NUMBER D2-14826

TITLE TECHNICAL FACILITY CRITERIA FOR THE MINUTEMAN LAUNCH FACILITIES - FRANCIS E. WARREN AFB, WYOMING (U)

The technical facility criteria document for the Minuteman Launch Facilities at Francis E. Warren AFB is issued as a supplement to the Wing III Launch Facility criteria presented in Boeing Document D2-13797. The complete Wing V Launch Facility criteria consists of the following:

D2-14828
FIG. 10-6.1
PAGE 38

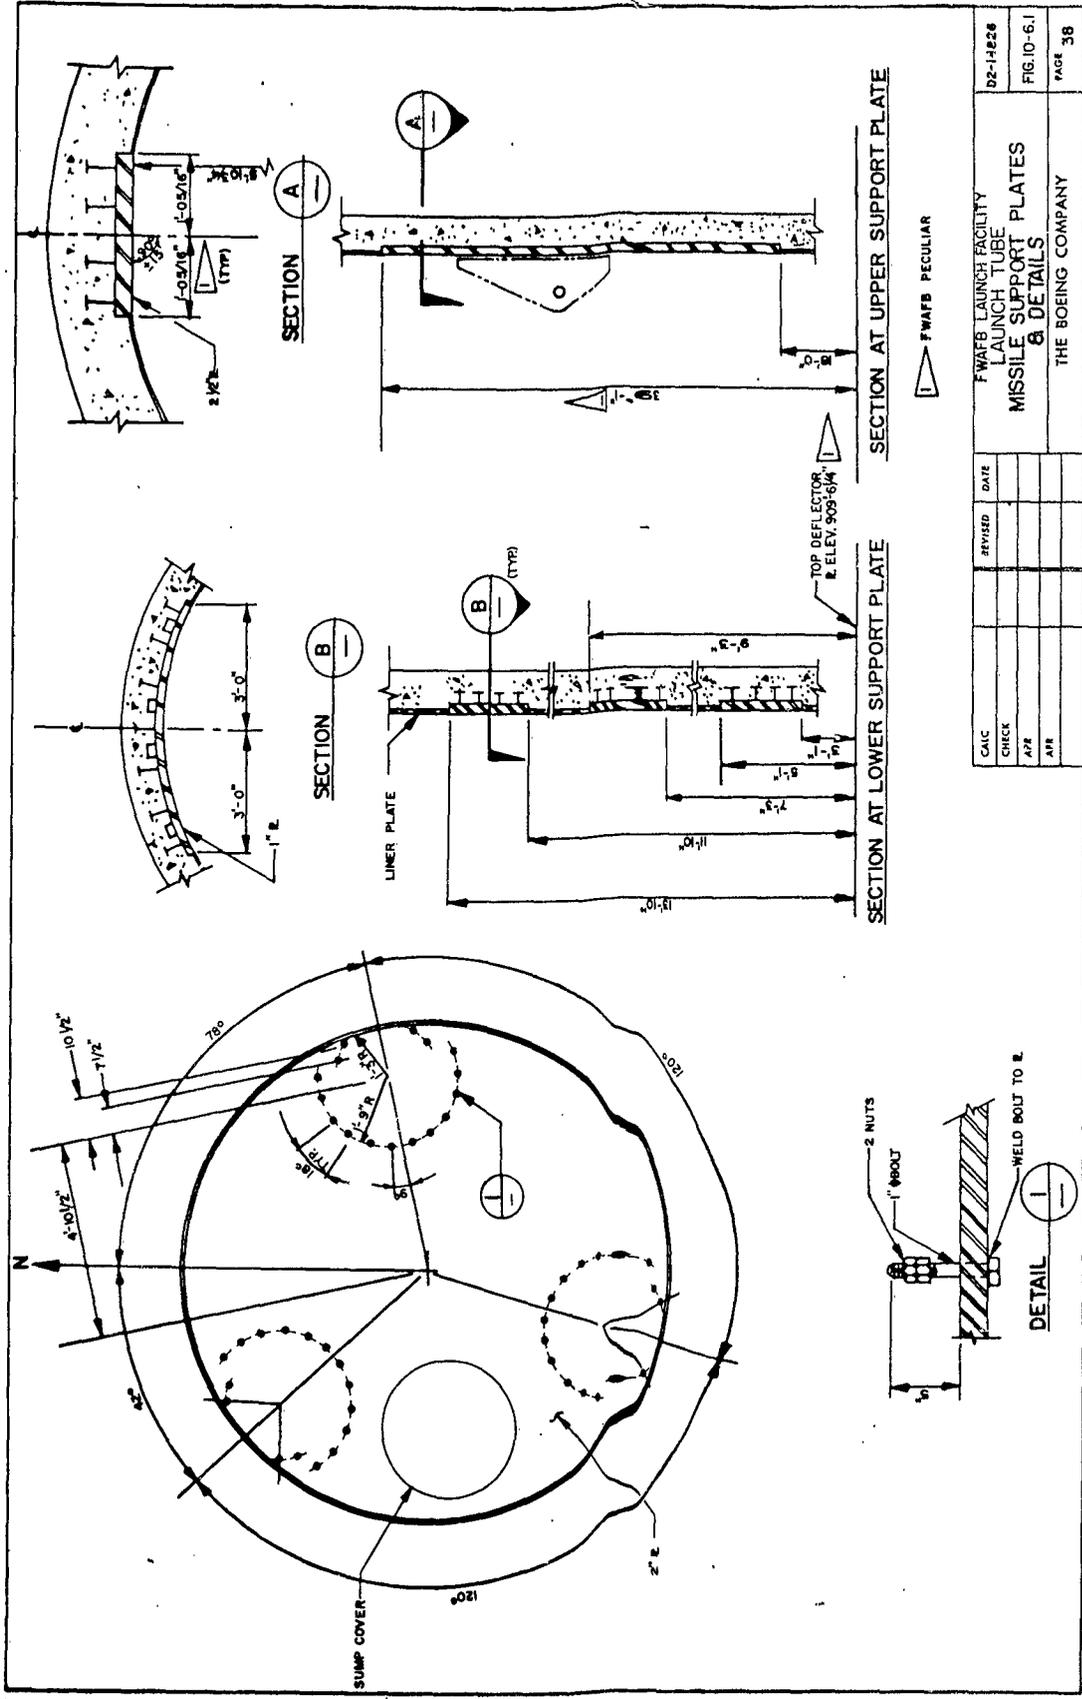
10.8.6 Figure 10-6.1 modifies dimension from deflector plate to top of upper support plate from 29'-1" to 39'-1". At Section A the dimension from centerline to outside edge of upper support plate is changed from 1'-0" to 1'-0 5/16".
